UNITED STATES PATENT AND TRADEMARK OFFICE

APPLICATION NO.	FILING DATE	FIRST NAMED INVENTOR	ATTORNEY DOCKET NO.	CONFIRMATION NO.
10/714,336	11/13/2003	Kenny Chang	JCLA11475	4087

Office Action Summary	Application No. 10/714,336	Applicant(s) CHANG ET AL.	
	Examiner Andrew O. Arena	Art Unit 2811

DETAILED ACTION***Claim Rejections - 35 USC § 103***

**FIG. 6**

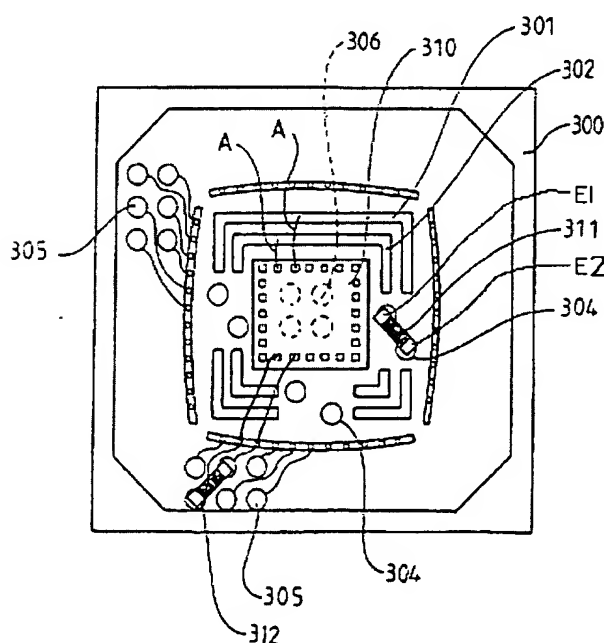
2. Claims 20-23 are rejected under 35 U.S.C. 103(a) as being unpatentable over Tao et al. (US 6,316,828) - hereinafter Tao - in view of Stearns et al. (US 5,895,967) - hereinafter Stearns - further in view of Yamaura et al. (US 6,831,360) - hereinafter Yamaura.
3. Examiner has attached a copy of Tao Fig. 6 to which has been added two reference numerals (E1, E2) used for clarity throughout this rejection.

4. Regarding claim 20, Tao discloses (Fig. 6) a package substrate (300; col 3 ln 41) adapted to carry a die (310; col 3 ln 46-48) of a wire bonding type (A; col 3 ln 37-38), the package substrate at least comprising:

a substrate (300; col 3 ln 41) having a surface, a power pad (301; col 3 ln 45-46) and a ground pad (302; col 3 ln 46), wherein the surface of the substrate having a die bonding area (310; col 3 ln 46), the power pad and the ground pad disposed outside the die bonding area;

at least one passive component (311; col 3 ln 42 – see 311 in Fig 5) disposed between the power pad and the ground pad (clear in Fig 6), the passive component having at least two electrodes (E1, E2) which are connected to the power pad and the ground pad (col 3 ln 44-46) respectively; and

Tao discloses the passive component electrodes are connected to the power pad and ground pad, but does not expressly disclose how the connection is made.
